Moriches Annex
For The
Mastics Moriches Shirley Community Library

Fire Sprinkler

October 11, 2021

Contract #15.300 Addendum #5:

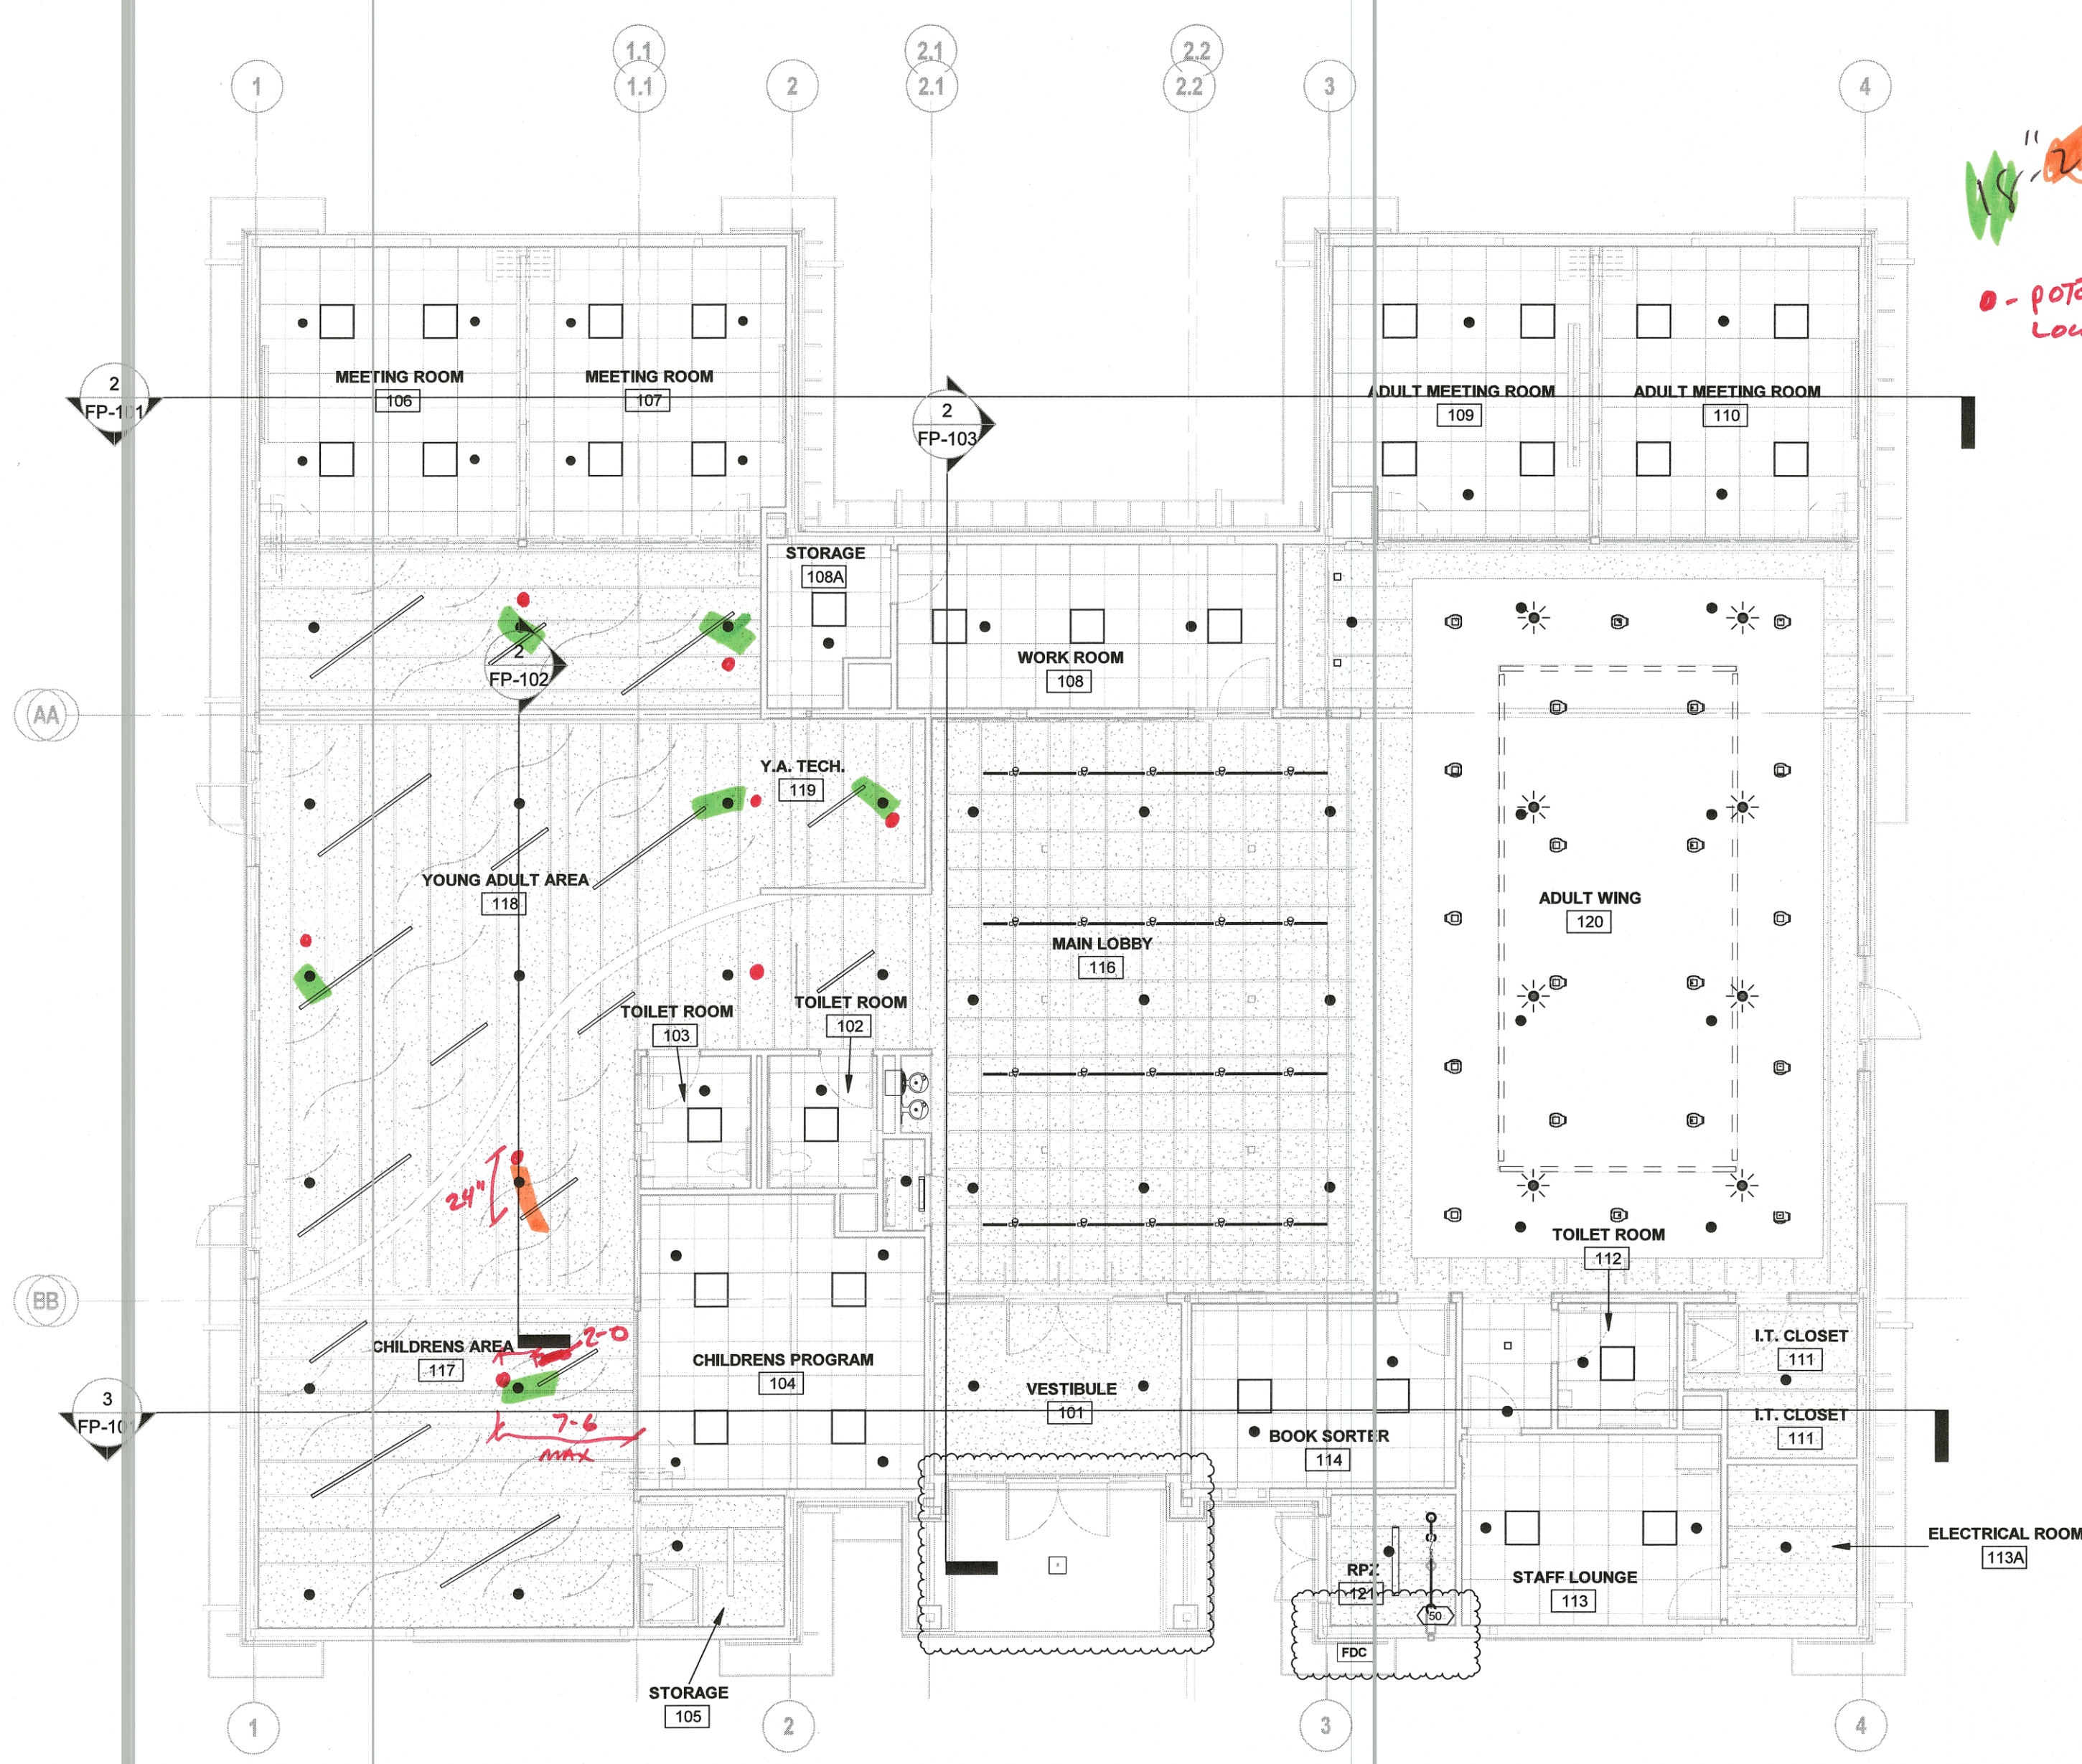
5. **QUESTION:** Per Section 8.6.5.2.2 of NFPA 13, 2016 edition we must be a minimum of 18-24 inches away from a suspended object that is 12" down from the ceiling. To play it safe, we'd like to be a minimum of 24" away.

The red dots represent my proposed locations, please keep in mind that the sprinkler head and baffle locations must be coordinated ahead of time. Any deviation in location could result in additional sprinkler heads needed and potentially increasing the hydraulic calculations, requiring larger pipe sizing.

ANSWER: H2M: I take no exception to the location changes, the suspended baffles can be manipulated a bit as well if the fire sprinkler locations take precedent.

FP-100

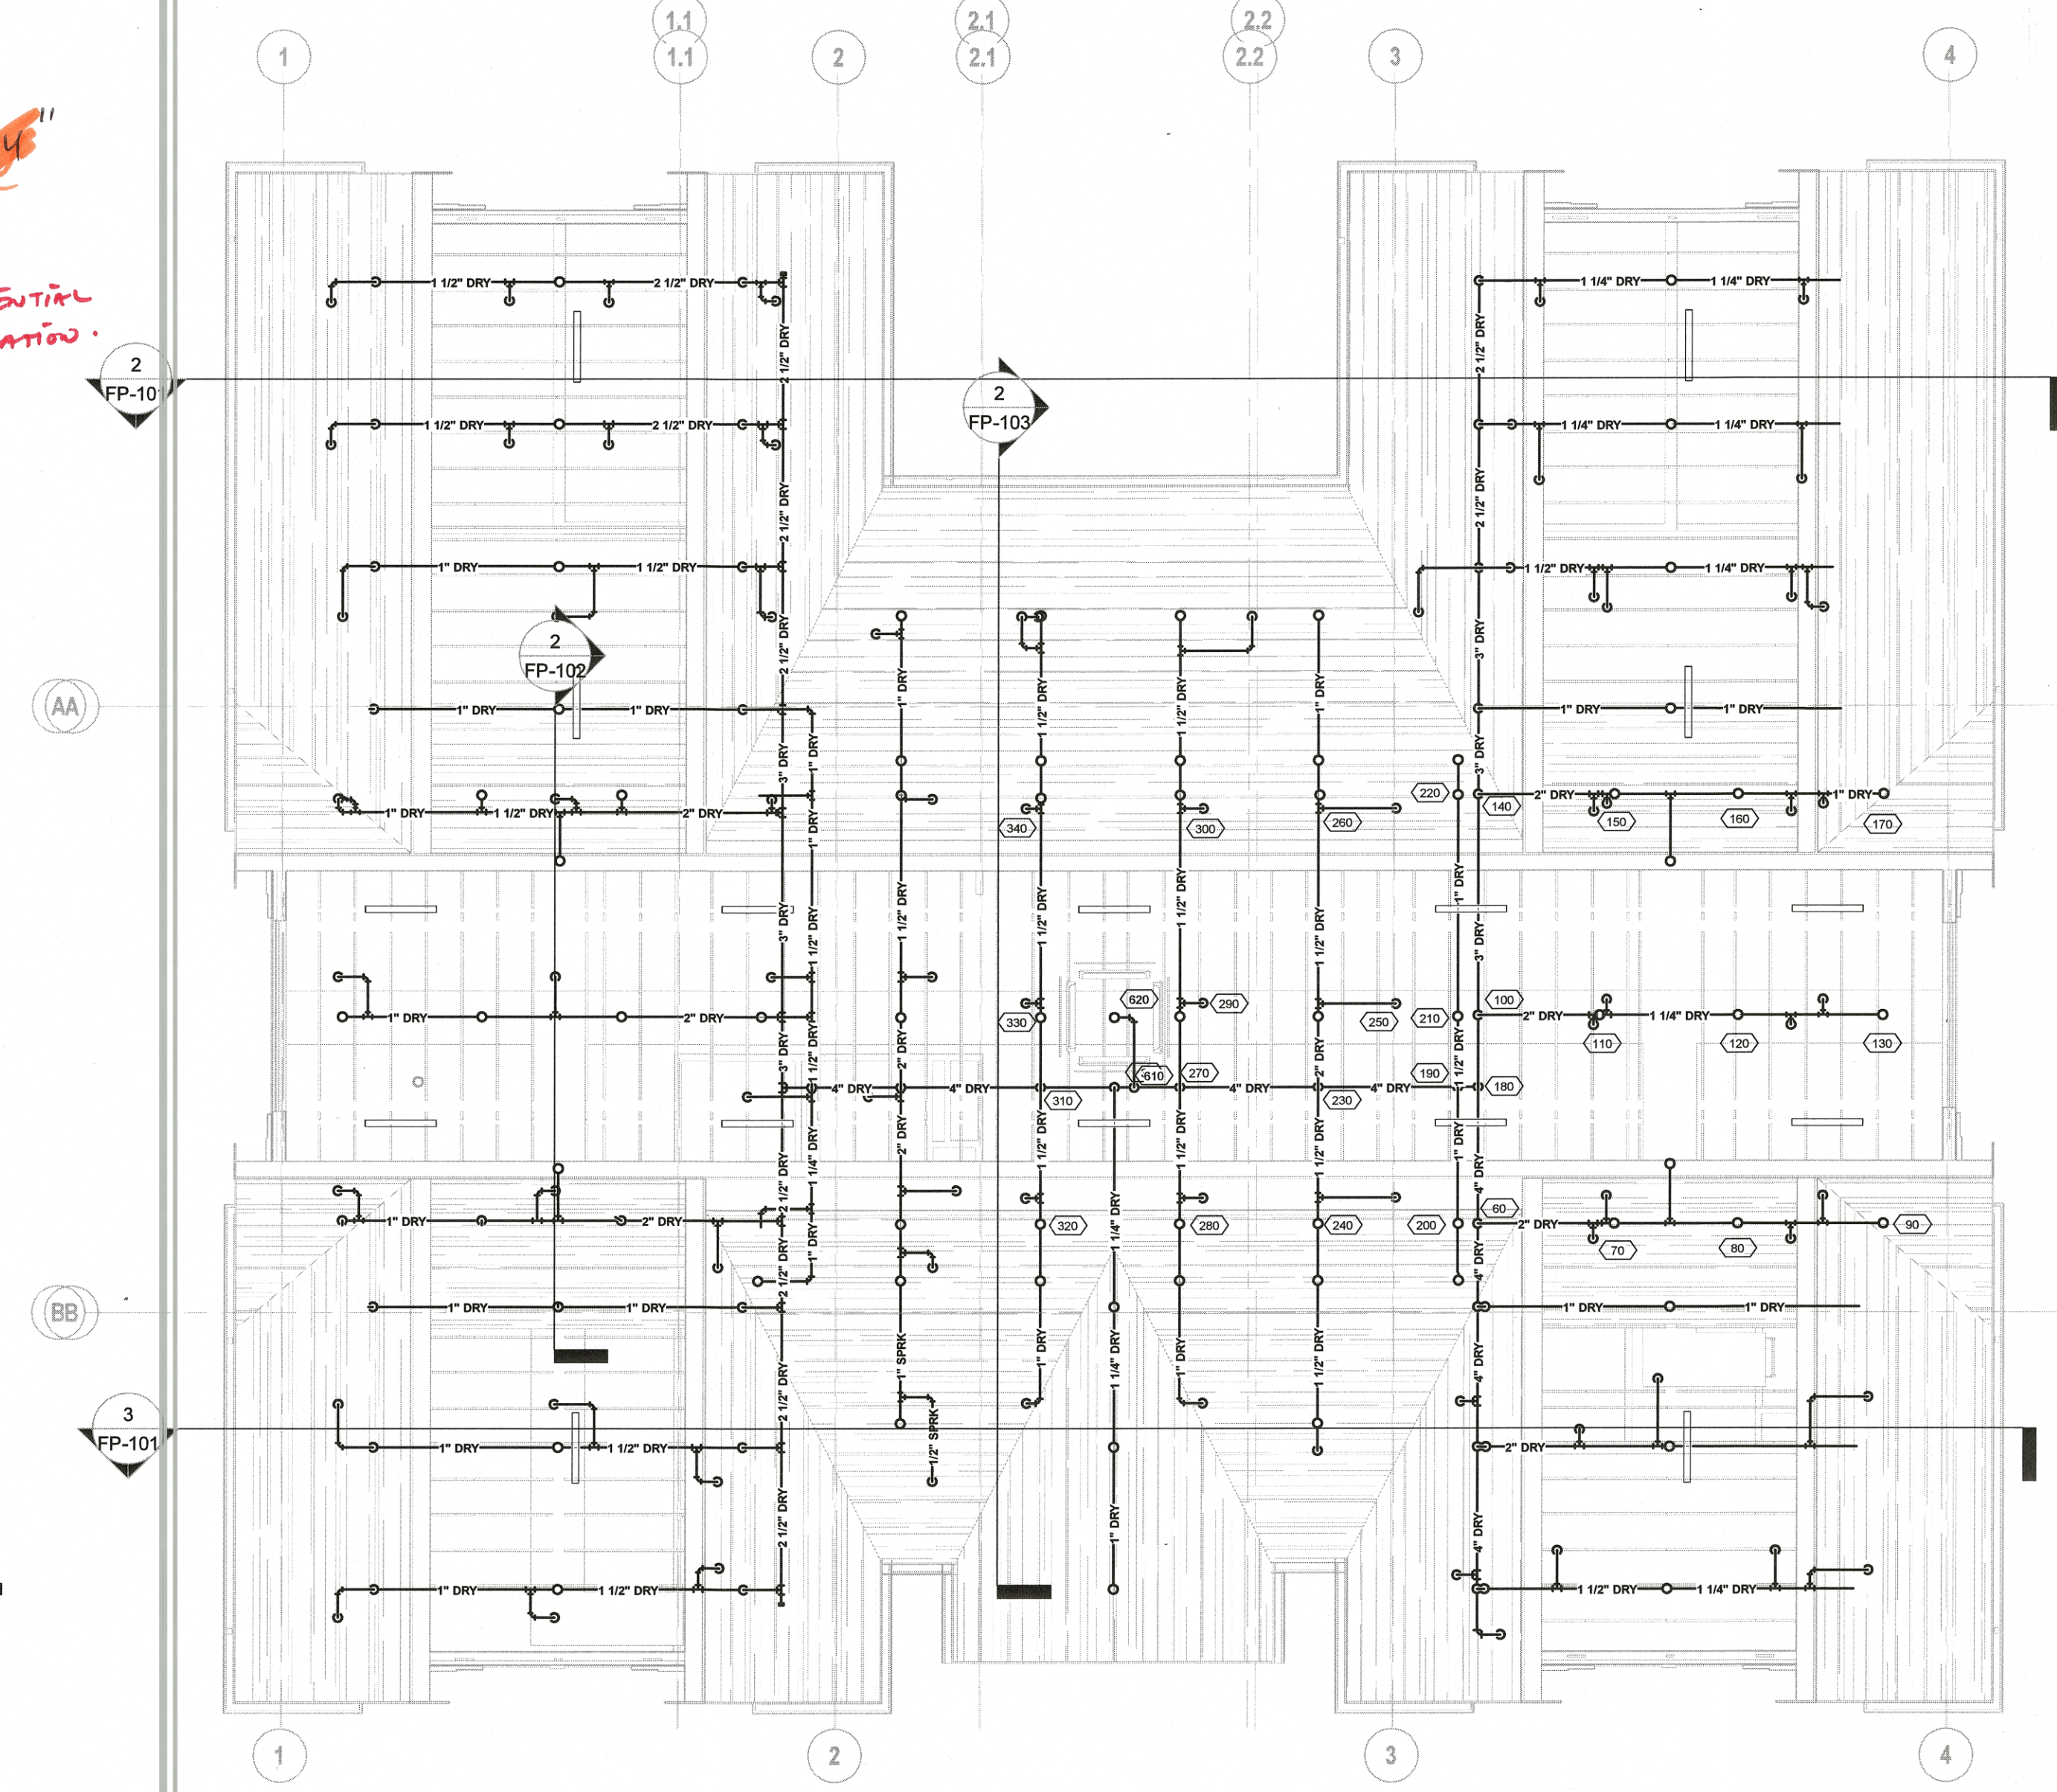
2. **QUESTION:** The Attic sprinkler system appears to be spaced greater than NFPA 13 allows for this type of construction. Can we confirm the layout shown on FP-100 is correct?

ANSWER: Spacing of sprinkler heads within shall be at a maximum of 8'-0" centers perpendicular to the slope (NFPA 13.8.6.4.1.4.4) which is reflected on the drawings. Final layout and spacing shall be the responsibility of the contractor and the contractor's fire sprinkler designer (211000.1.2).
